OBJECTION to application 2025/NMA/92783/E

Further to the above application, the matters referred to **are not non-material amendments** to previous permission 2024/93227 for variation condition 2 (plans) on previous permission 2020/94345 (APP/Z4718/W/21/3289729) for erection of 5 dwellings.

Above Plan - Errors and Omissions:

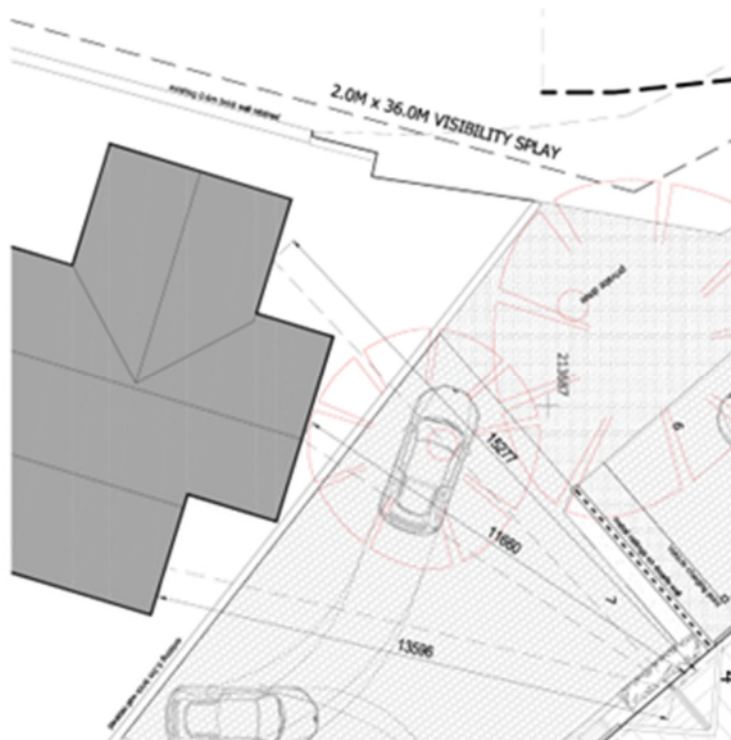
Plan does not show separation distances:

The plan refers to a 1.1m wood fence, - if this is my existing fence (now [repeatedly] vandalised) it is shown in the wrong position. The fence extends from the line of my boundary, continuing from existing wall – **correction required**

Plans do not show a 600mm hardstanding to the proposed road on the south/western side of the proposed access road. This requirement is stipulated in Kirklees Highways Design Guide SPD, along with other requirements, incl. drainage shown on approved plans:
